**GULF STATES UTILITIES COMPANY**

River Bend Station - Unit 1  
Docket No. 50-458

Enclosed for your review are Gulf States Utilities Company responses to the open items identified in the Draft Safety Evaluation Report by the Auxiliary Systems Branch and responses to the request for additional information identified in part by Staff letters dated August 5, 1981 and December 31, 1981. This letter supplements docketed correspondence from Mr. Booker to Mr. Denton dated December 1, 1983, December 30, 1983, February 2, 1984 and March 6, 1984. Attachment 1 summarizes the open items and indicates changes to be made in the River Bend Station FSAR. Attachment 2 provides a brief discussion of each open item, the response and reference material for each item. Where indicated, these responses will be provided in a future amendment to the FSAR.

Attachment 1

FIGURE 9.1-3

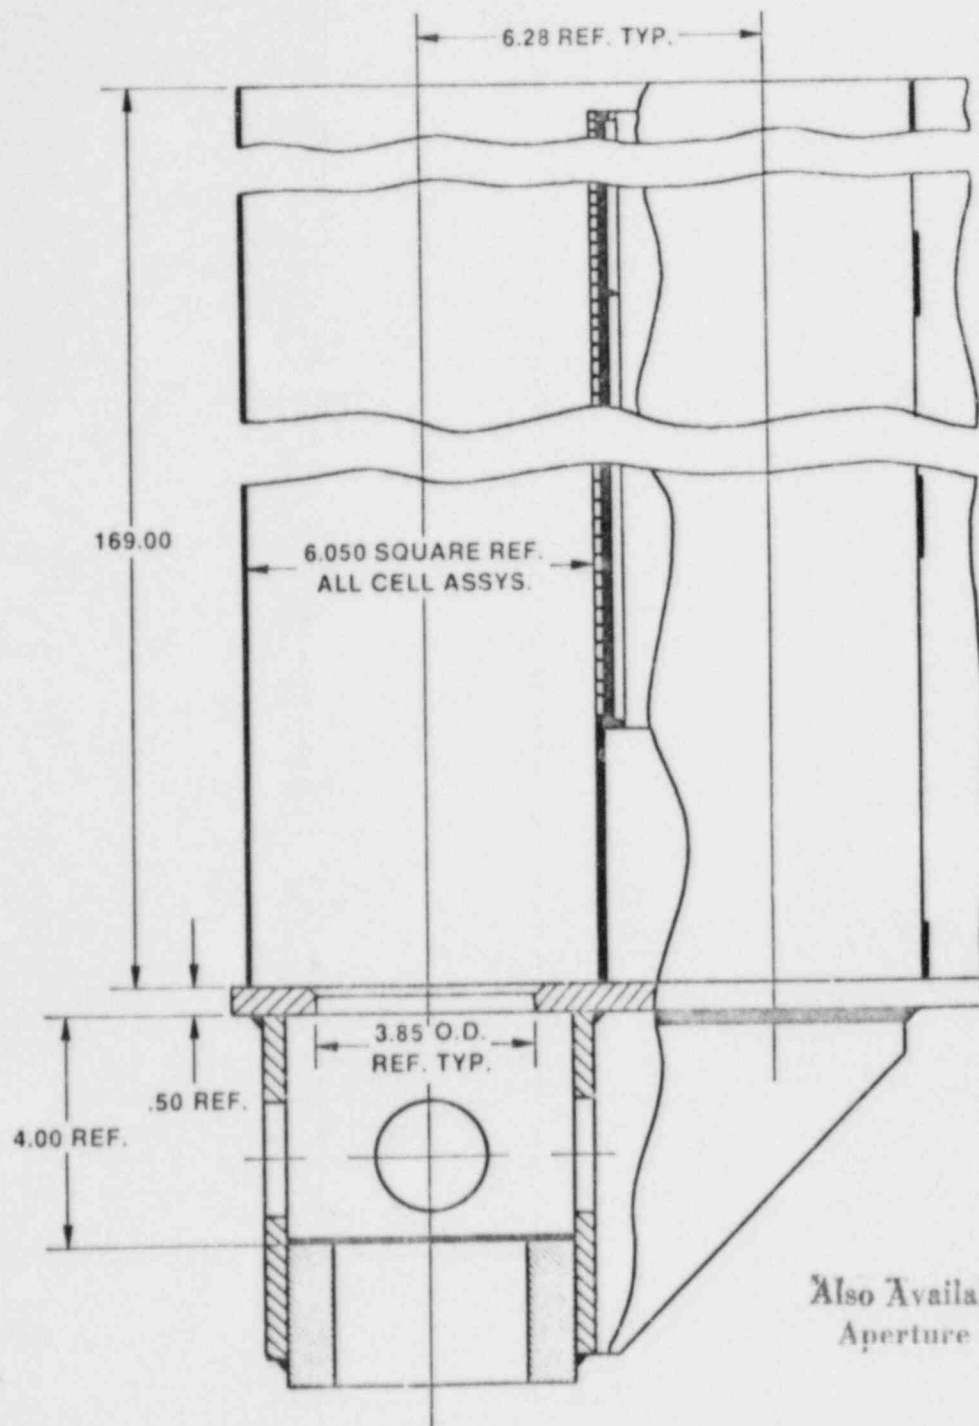
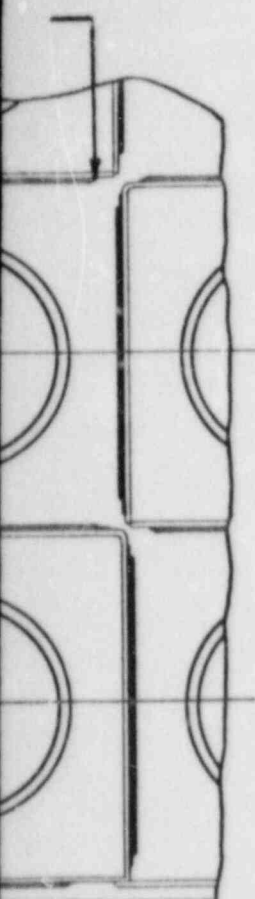
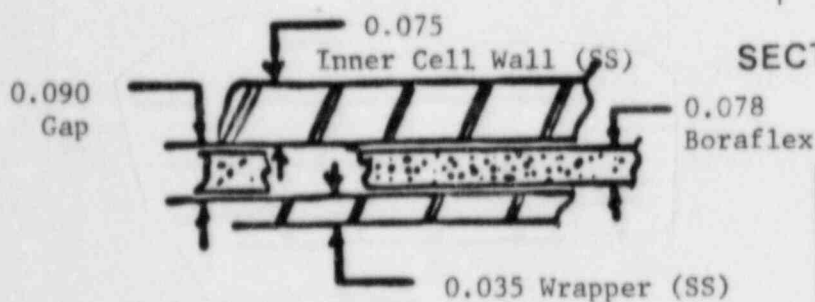
8. The applicant has not provided a criticality analysis to confirm the criticality limits to be attained in the spent fuel storage facility. (DSER Pages 9-10 & 11).

QUESTION 410.6 (9.1.2.3.1.2)

Provide a schedule for submittal of the criticality analysis for the fuel building spent fuel storage or provide the analysis.

7. The array is infinite in lateral and axial extent which precludes any neutron leakage from the array, and is thus more reactive than the actual finite array. Figure 9.1-3 (sheet 4 of 4) shows the nominal dimensions of individual cell modules and indicates the unit cell modeled in the "infinite array".

The calculation of Keff for the above nominal case results in a Keff of 0.9190 with a 95 percent probability/95 percent confidence level uncertainty of + 0.00379. When mechanical and method biases and uncertainties are included (e.g., tolerances for mechanical construction that can result in reduced cell center-to-center spacings, and storage cell material thickness), the total uncertainty is 0.02 Delta K resulting in a Keff of 0.9390; thus, the acceptance criterion for criticality is met.
